**Town of Nags Head Planning Board
Nags Head Municipal Complex Board Room
Tuesday, June 18, 2024; 9:00 a.m.**

Subject: Site Plan Amendment for Inn at Whalebone, 87-unit Hotel located at 6632 W. Pheasant Avenue (W. Lakeside Street).

At this time, the applicant is requesting that consideration be given to various Site Plan amendments as well as a request to eliminate in whole, or modify, the requirements imposed by Condition #1 as it relates to the widening of Lakeside Street.

1 C-101 PROPOSED TURN LANE DETAIL / CALCULATIONS NTS

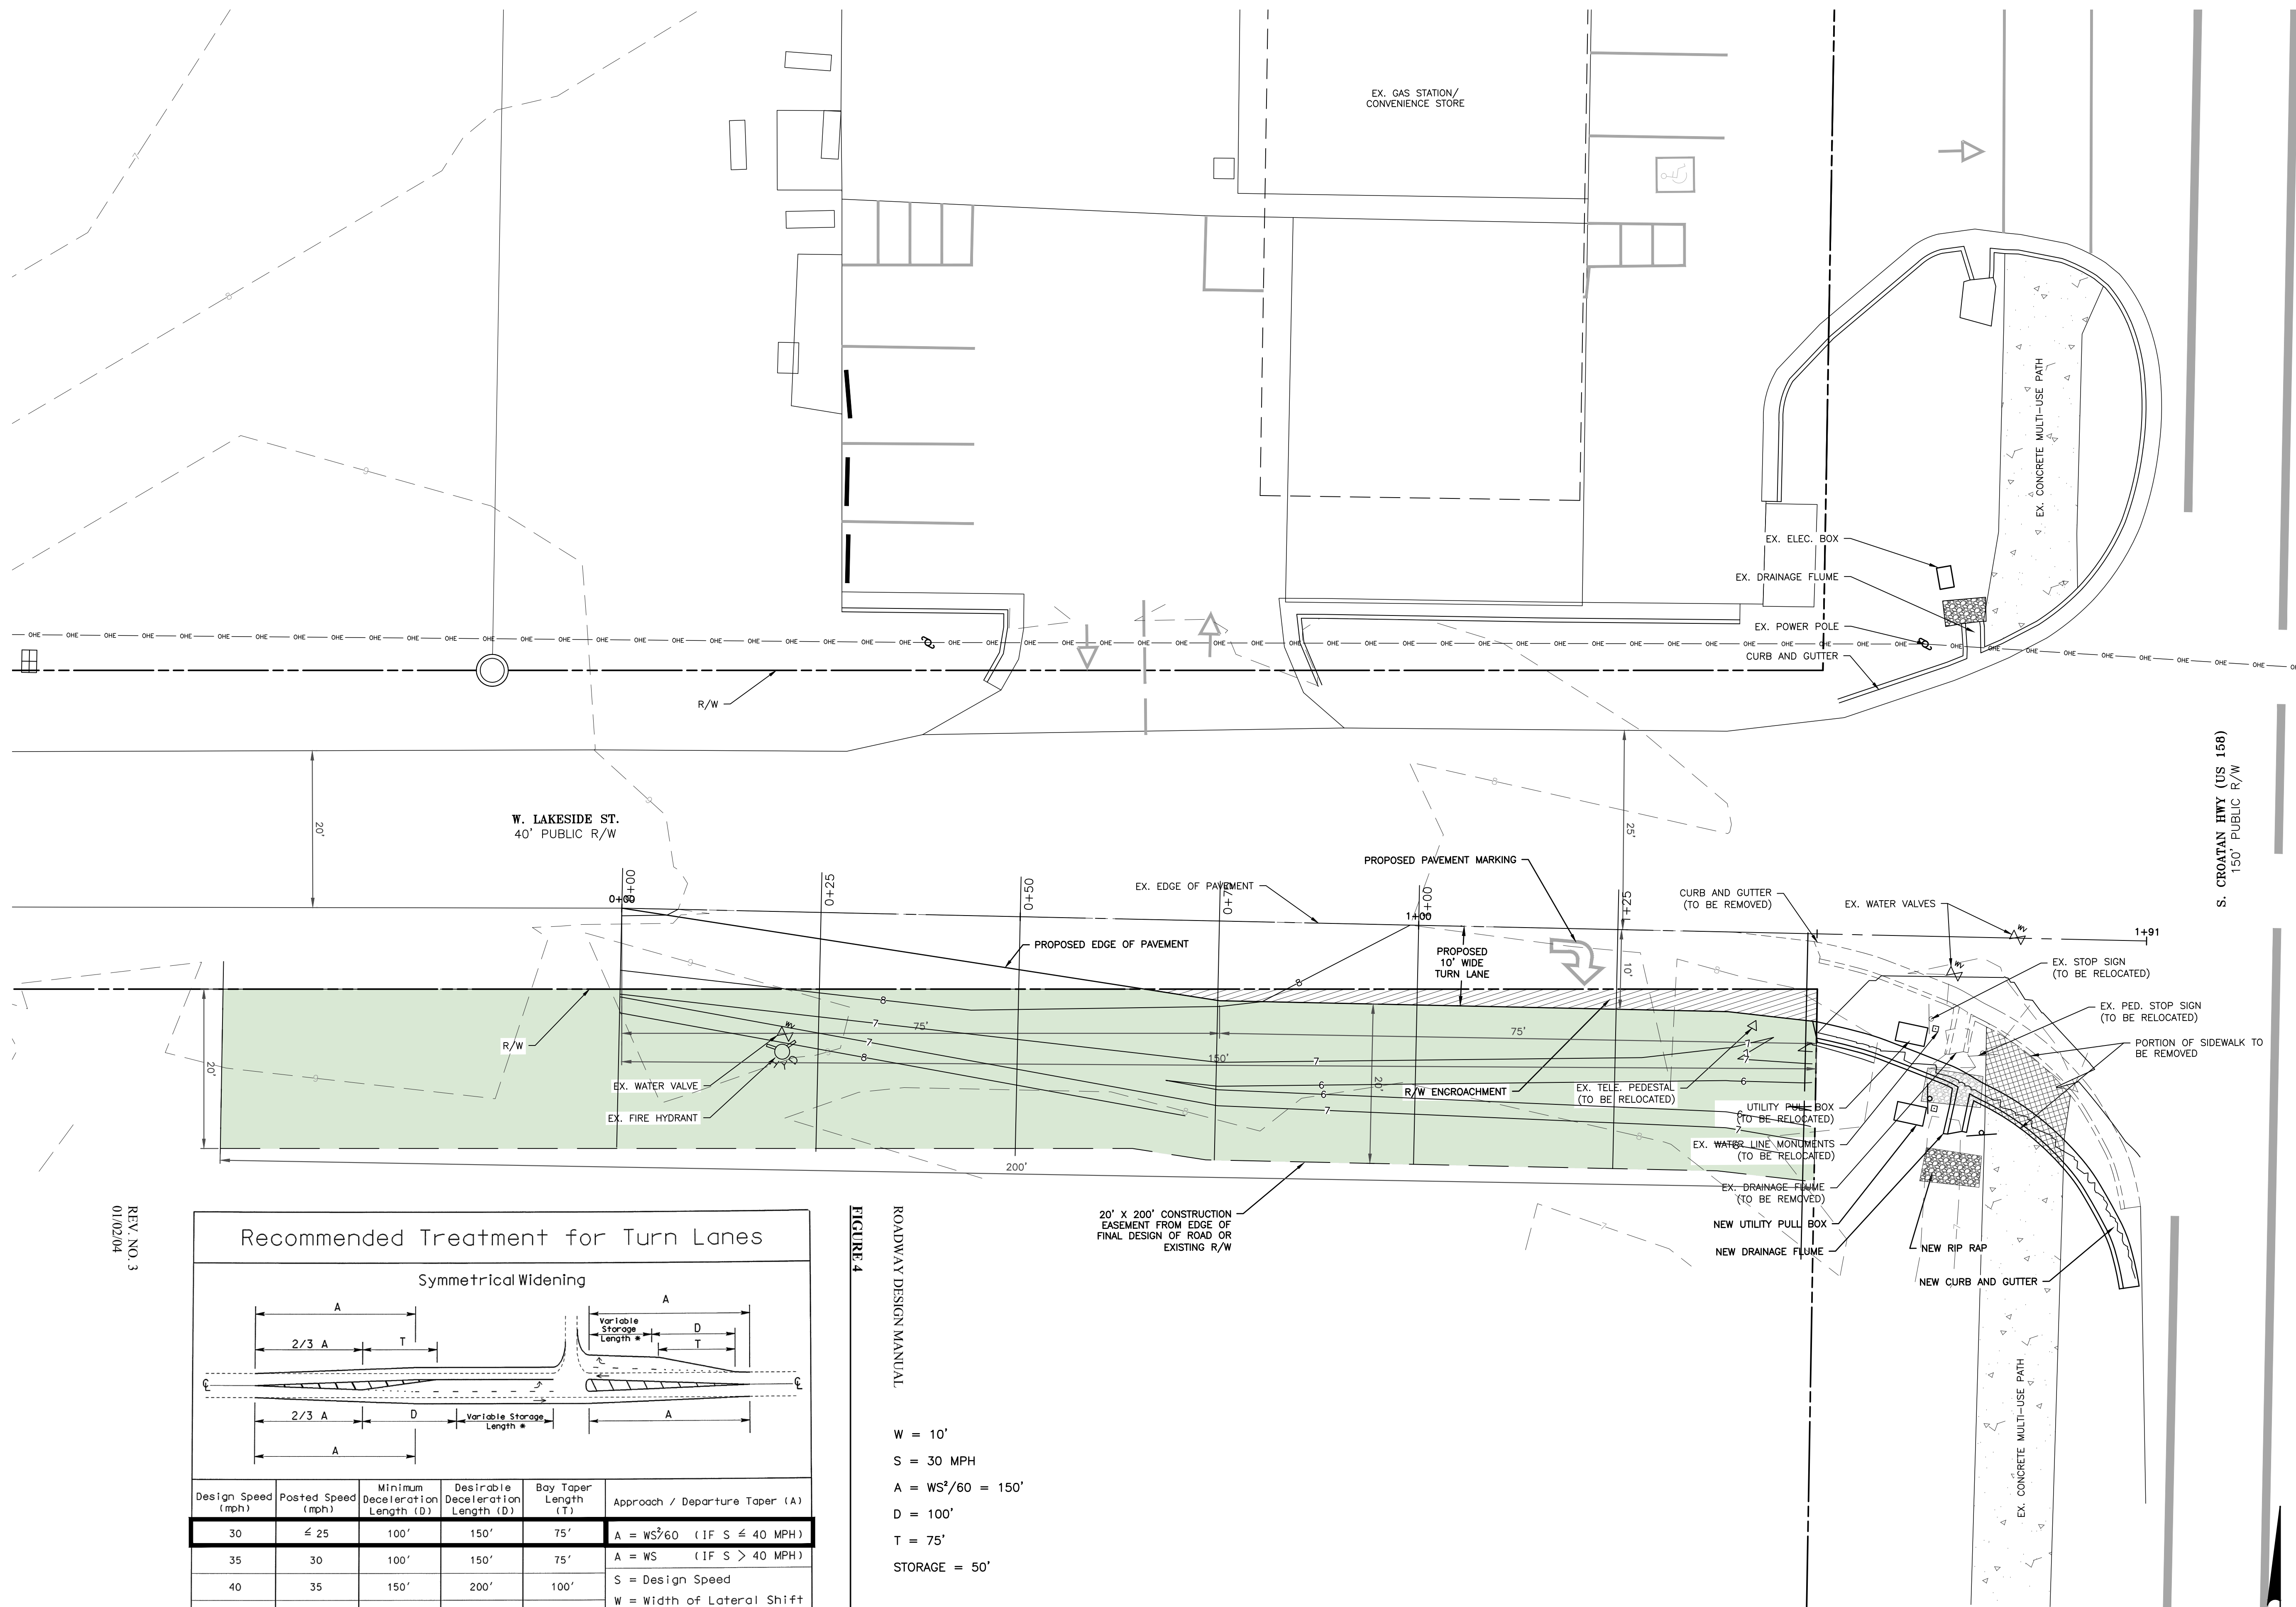
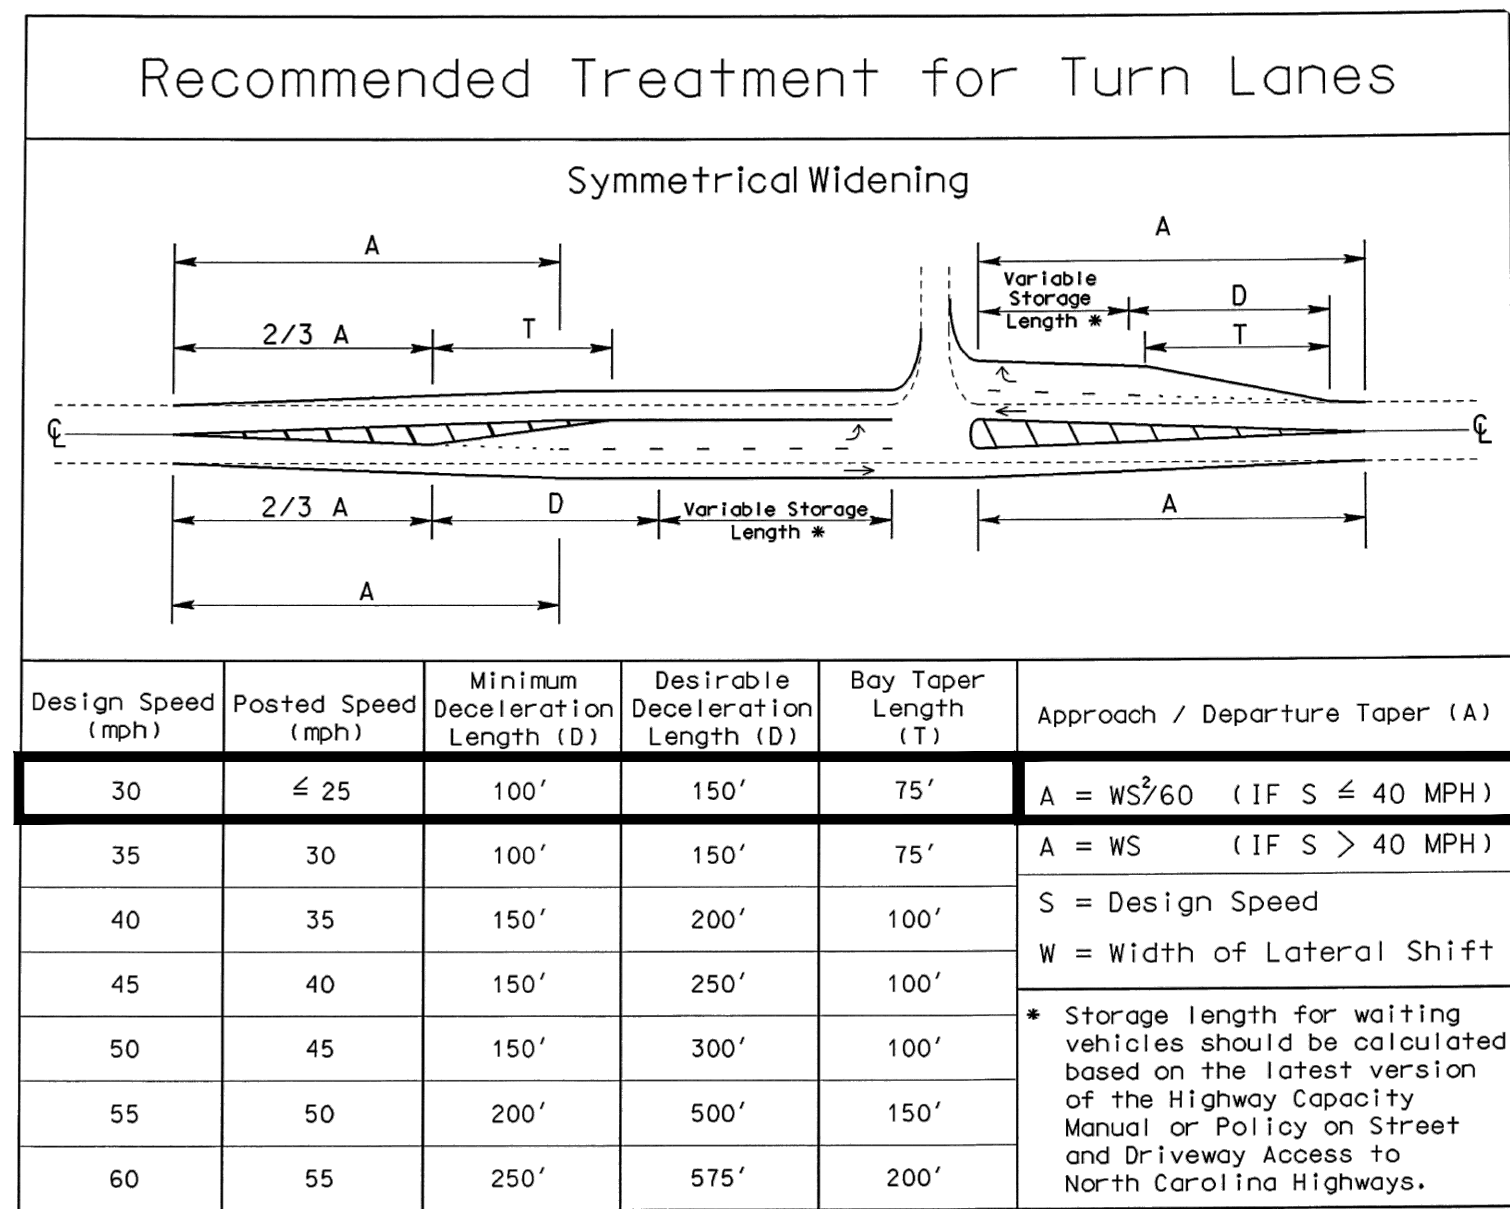
“Lakeside Street Turn Lane Exhibit- A condition was placed on the previous site plan approval to widen the Lakeside St roadway extending from S. Croatan Hwy. to the westernmost boundary of the subject property. With the existing Lakeside St. right-of-way width at 40’ there are some impacts associated with a roadway widening of this length. These impacts include runoff onto adjoining properties and potential conflicts with above ground utilities. However, there is still an opportunity to provide roadway widening to meet the intent of the previous Board of Commissioners conditioned approval.

The applicant has submitted an exhibit which shows a reduced widening plan from the eastern property boundary. This concept indicates an encroachment onto the adjoining undeveloped property to the south. Attached is an exhibit mark-up which describes a potential alternative roadway widening approach which may not result in improvements extending onto private property. The recommendation is for the applicant to modify the traffic improvements for Lakeside St. to reflect the approach as identified in the attached plan mark-up. This approval would be conditioned on the applicant acquiring detailed survey information for the development of a roadway widening and construction plan in accordance with Chapter 36-4 of the Town Code of Ordinances. It should be noted that a temporary construction easement may be required from the owner of the undeveloped property to the south for the purposes of construction in addition to a right-of-way encroachment through NCDOT.”

Regarding the applicant's request to remove or modify the condition to widen Lakeside Street, this condition was included in the October 4, 2023, Board of Commissioners (BOC) approval to address traffic concerns raised by citizens and Board members. While fully meeting this condition could impact runoff onto adjacent properties and conflict with above-ground utilities, there is an opportunity to widen a portion of the roadway. This approach would fulfill the intent of the Board of Commissioners' conditioned approval without encroaching on adjoining properties. Staff recommends that the Planning Board recommend modifying the previous BOC approval to reflect the alternative roadway design proposed by the Town Engineer.

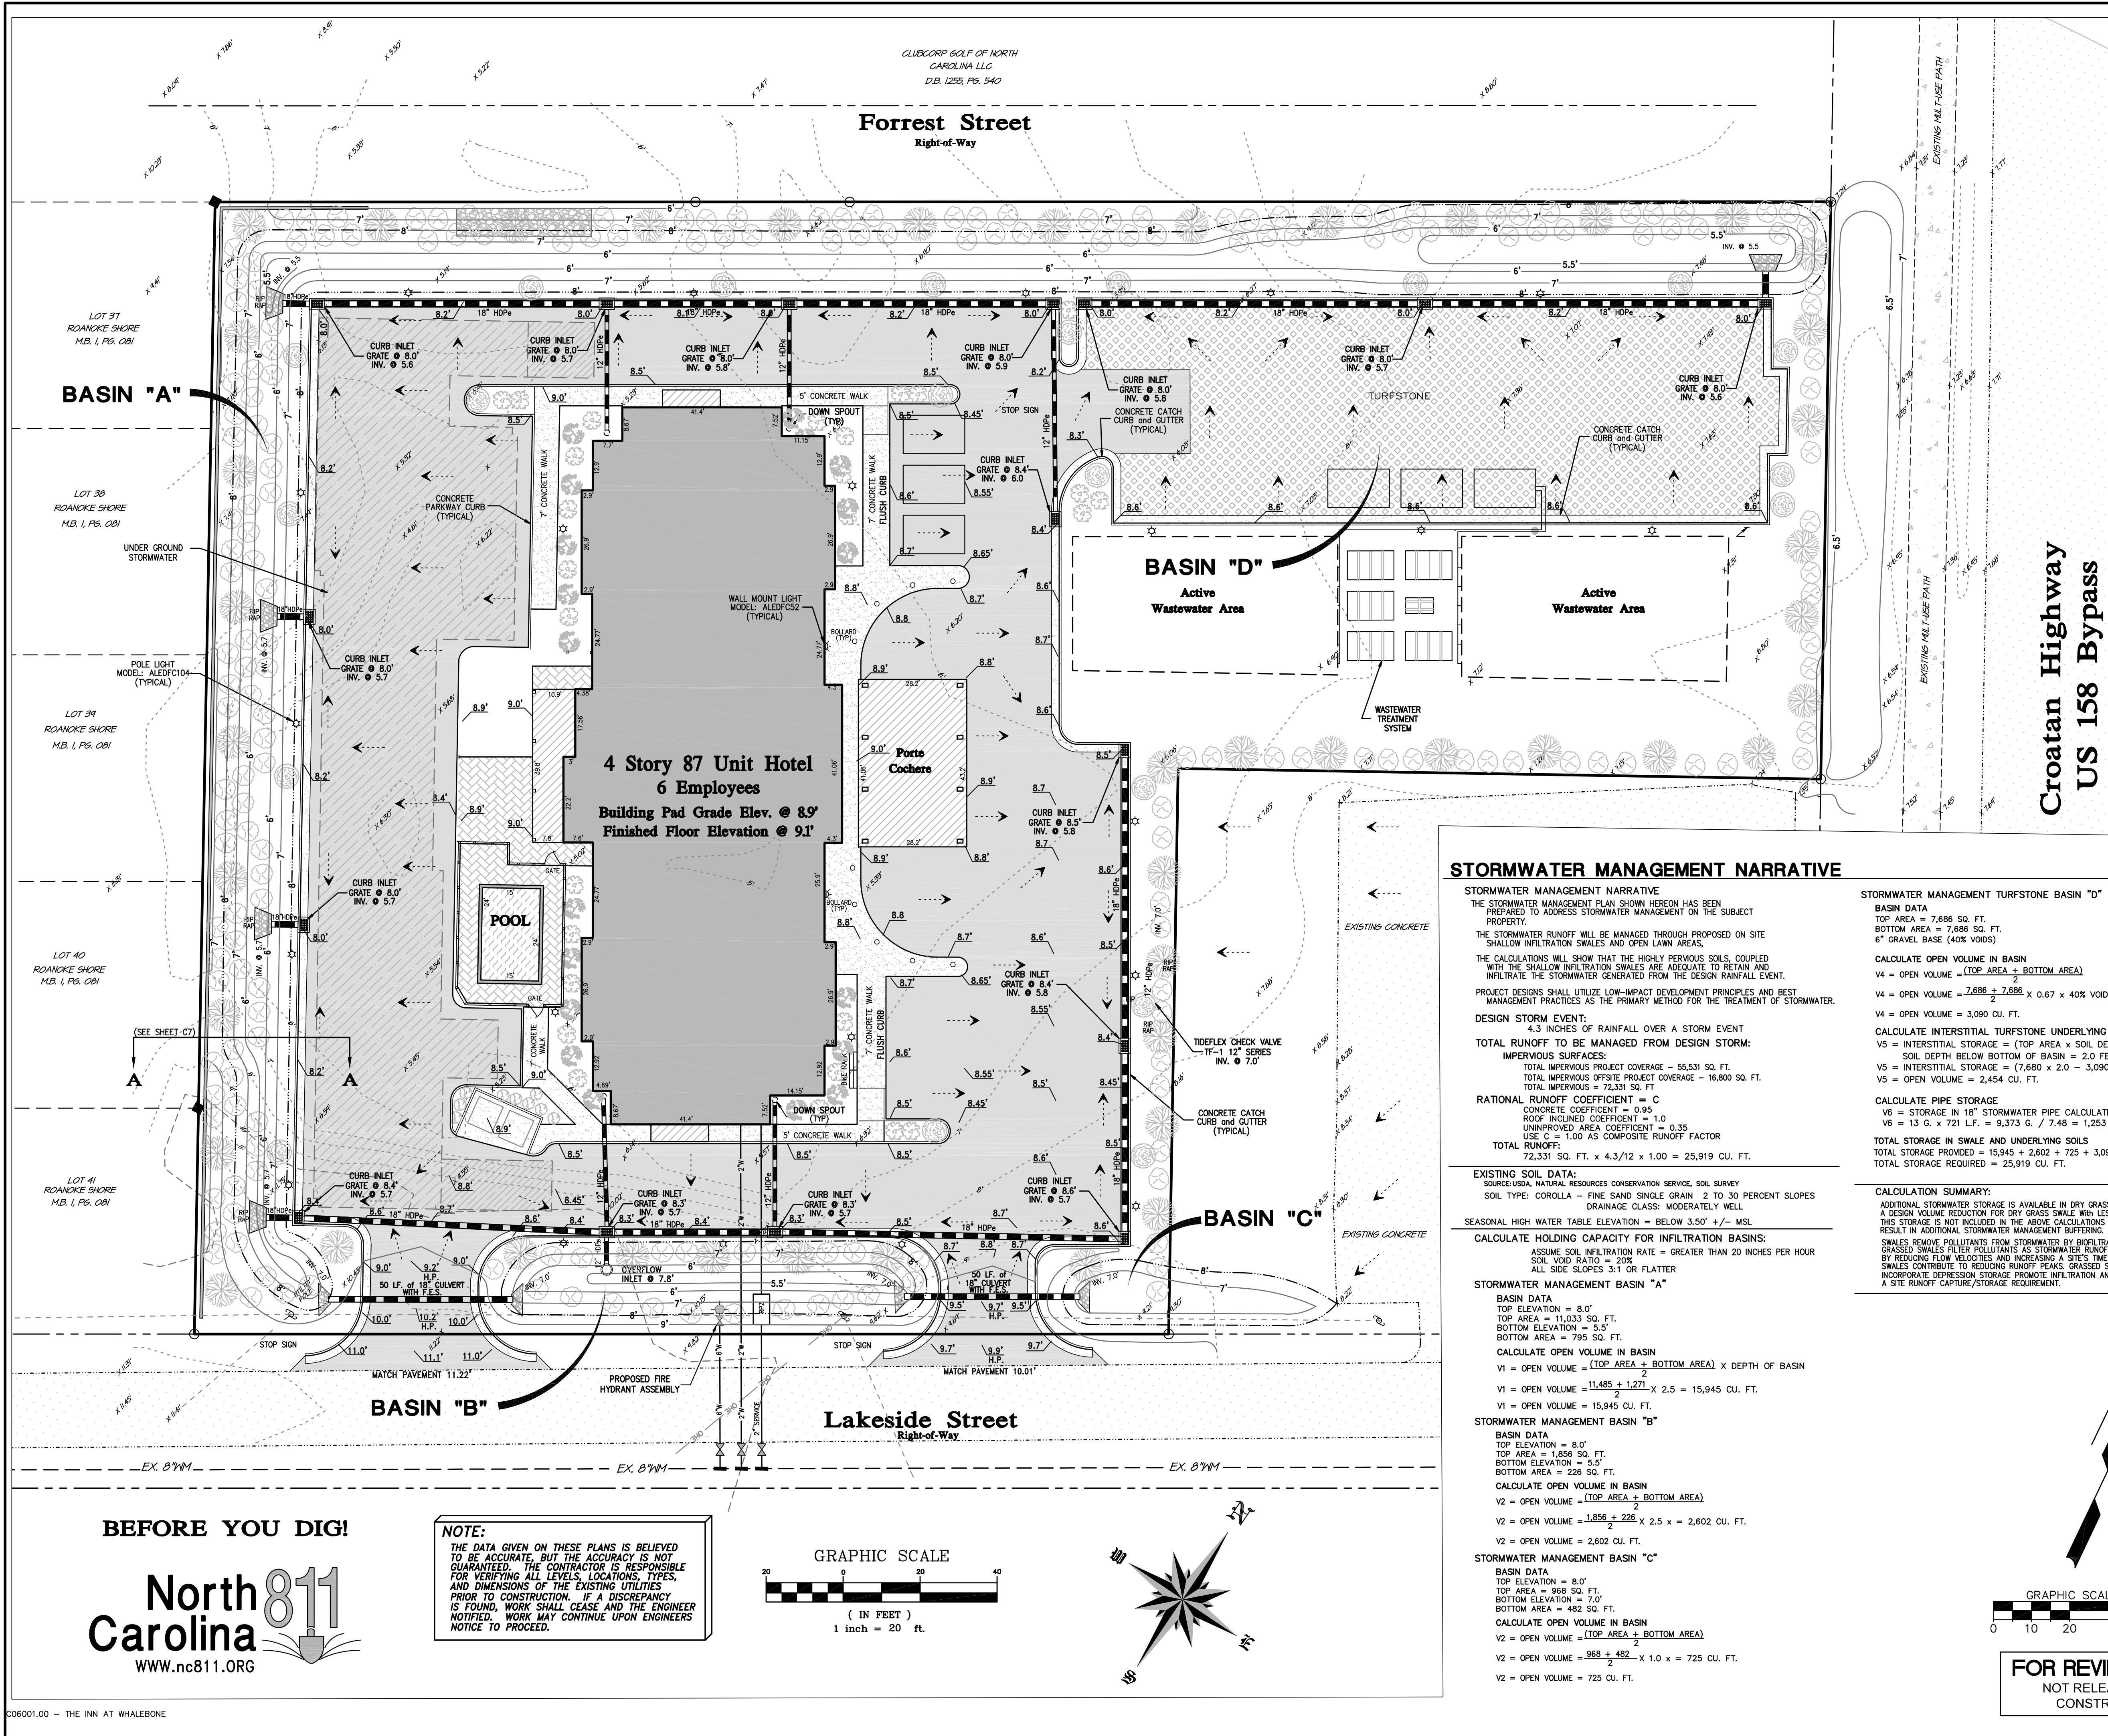
Town Engineer David Ryan has reviewed the revised plans and notes that the stormwater narrative on Sheet C-103 indicates a Seasonal High Water Table Elevation of 3.50' MSL. The typical infiltration basin detail indicates a SHWL of 4.8'. This discrepancy should be clarified. The stormwater management design information submitted appears to be in substantial compliance with the Town of Nags Head Unified Development Ordinance.
